No. EL/3.2.85

Amendment-2

Modification Sheet No. RDSO/2009/ELRS/MS/0374 (Rev.`1') amendment-1 dated 22.09.2011

Modification of Bellows and its Mounting arrangement on New Traction Motors type 6FRA6068 used in WAG9/WAP7 class of Locomotives (new manufacturing).

- S.	1				6/ LO		CO	MS PLAT	E IS: 2062
REF. NO.	PART NO.	DESCRIPTION		DETAI	DETAIL DRG. NO.		LOCO	MATL. SPEC.	
SCALE - N.T.S. APPD. BY (FOR DG.)									
MODIFIED BELLOW TOP PLATE FOR WAG9/ WAP7 LOCOS								T ISSUED	
									SKEL 4763
RDSO ELECT. DTE.					SKEL-4894		SUPERSEDED BY

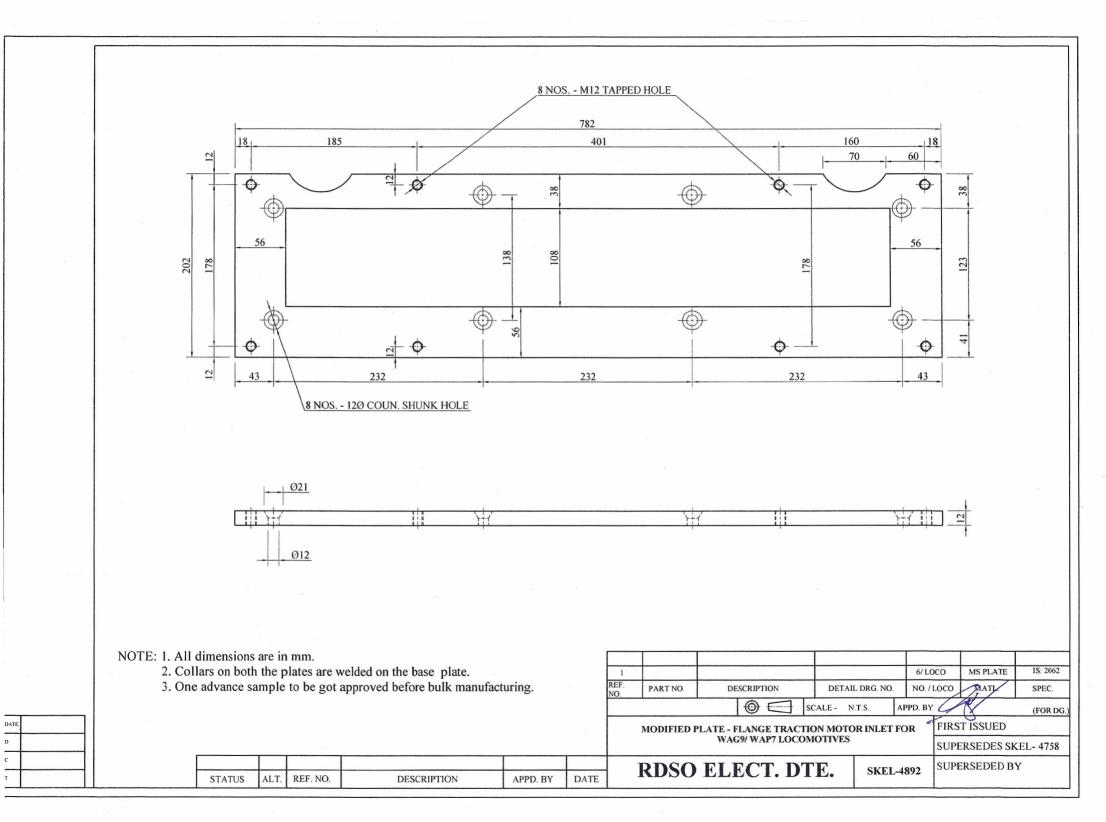
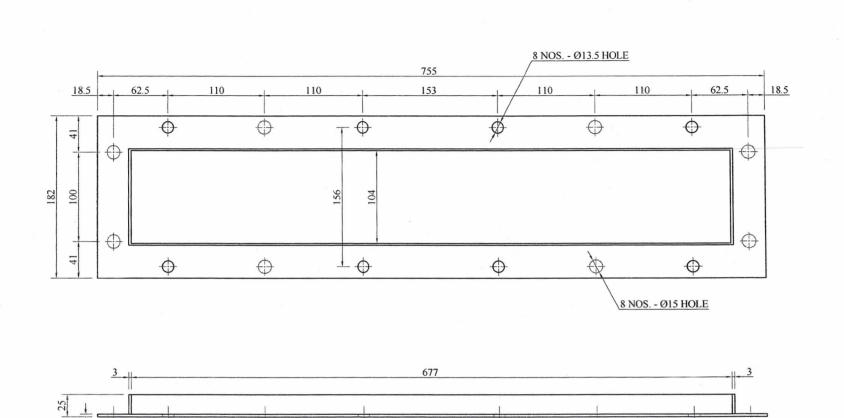
- 1.8. Its salient features are listed below:
 - 1.8.1.Flanges of top and bottom spacer plates of bellow have been made wide enough (in line with Hitachi TMs) while keeping the internal dimensions unaltered. Bellows top and bottom plates have also been suitably modified. With this arrangement, these bellow plates can be tightened together with nut and bolts outer while spacer plates can be welded on end shields.

- 2.2. Use single duct leather bellow as per RDSO's drg no. SKEL-4893 Alt.'0' along with modified bellow bottom plate as per RDSO's drg. No. SKEL-4891 Alt.'0' to secure the bellow at traction motor end with the help of 12 mm size nut and M12X30 grade 8.8 bolts.
- 2.3. Provide modified top plate with flange as per RDSO drg. No. SKEL-4894 Alt. '0' to secure the bellow with locomotives with nuts(size 12 mm).

2. Collars on both the plates are welded on the base plate.

3. One advance sample to be got approved before bulk manufacturing.
